Access Compliance Report

Public Rights-of-Way

| Intersection ID: 53224 | Main Street: URBAN_PL | Cross Street: GIVENS_WY | Location: NE |
| ADA ID: BD1E53CDE1CE | Ramp Type: PerpDiag | Initial Pass/Fail: Fail | Overall Compliance: No |

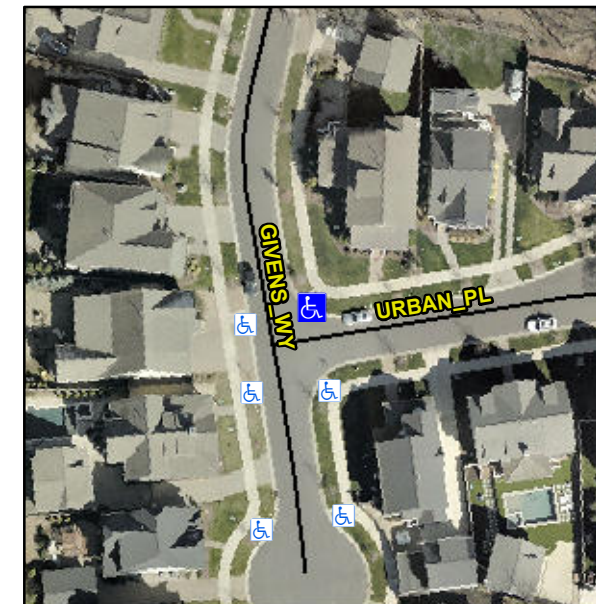
Not Found, R304.5.1, R304.2.2

| Compliance | Description | Data | Compliance | Description | Data |
|------------|-----------------------|------|------------|-----------------------------|------|
| N/A | Ramp Length (in) | 94.5 | No | Ramp Slope (%) | 9.1 |
| No | Ramp Width (in) | 45.0 | Yes | Ramp XSlope (%) | 1.7 |

Remove & Replace Curb Ramp With Two New Directional Ramps or Equivalent.
